## IDAP REPORT

<b>Property:</b>	5 Wakeford Road STRATHFIELD Lot: A DP: 386343 DA2021.11
<b>Proposal:</b>	Demolition of existing structures, tree removal and the construction of a two (2) storey dwelling house with basement level, swimming pool and outbuilding.
<b>Applicant:</b>	T Harb
<b>Owner:</b>	MS Matar and V Gorelik
<b>Date of lodgement:</b>	4 February 2021
<b>Notification period:</b>	15 February to 1 March 2021
<b>Submissions received:</b>	Nil
<b>Assessment officer:</b>	M Rivera
<b>Estimated cost of works:</b>	\$1,299,463.00
<b>Zoning:</b>	R2 – Low Density Residential - SLEP 2012
<b>Heritage:</b>	No
<b>Flood affected:</b>	No
<b>Is a Clause 4.6 Variation Proposed:</b>	No
<b>RECOMMENDATION OF OFFICER:</b>	<b>APPROVAL</b>

**Figure 11:** Void spaces adjacent to the stairwell and above the formal dining room

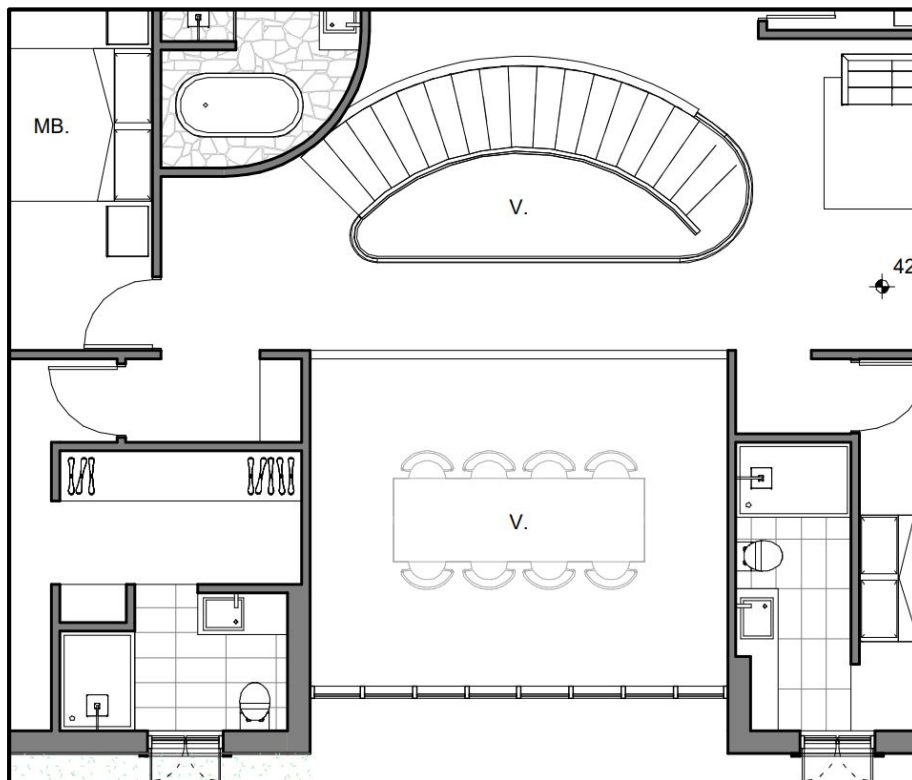
The void spaces included in the first floor of the design are considered reasonable and acceptable. These voids relate to the stairwell and the formal dining room (refer to Figure 11). The void above the formal dining room provides additional solar access and amenity for this room and is further recessed compared to rest of the western wall. It is also noted that any bulk and presentation by this void space will primarily affect the access handle of No. 5A Wakeford Road. The 1.3m setback of the building combined with the width of the access handle will further minimise the presentation of the western wall from the neighbouring residence at No. 7-9 Wakeford Road.

To ensure that the void space above the formal dining room remains a void an ongoing condition will be included in the consent.

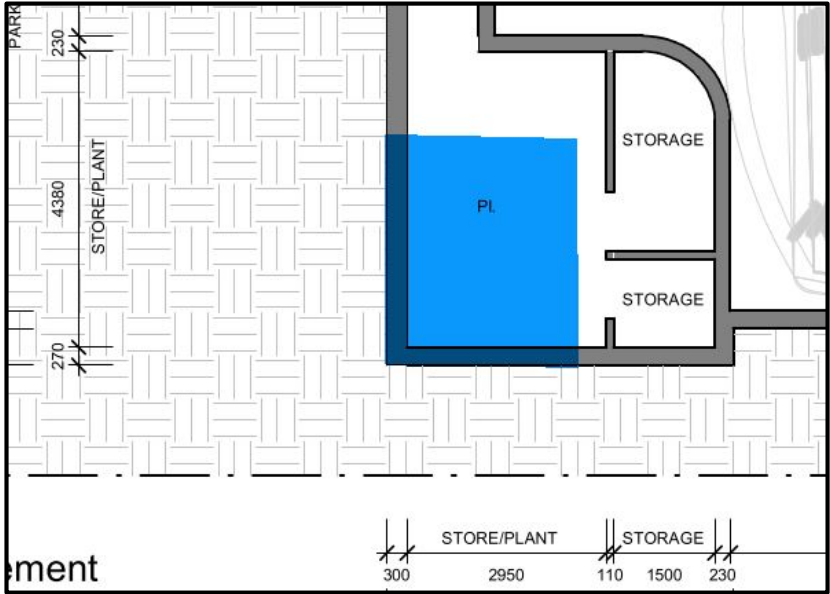
Reduced building footprint	<p>A portion of the plant room in the basement is to be deleted (see figure below – shaded in blue).</p>  <p>A portion of at least 0.5m must be deleted from the lounge room (ground floor) and bedroom 3 (first floor) (see figure below – shaded in red).</p> 
Trees to be retained and protected	<p>The existing trees on site – <i>Jacaranda mimosifolia</i> (Jacaranda) and <i>Leptospermum petersonii</i> (Lemon scented Tea Tree) that are located in the rear yard must be annotated on all approved plans as trees to be retained.</p>
All architectural plans and documents	<p>All references to and annotations that relate to a proposed Dual Occupancy must be deleted from all approved plans and documents.</p>
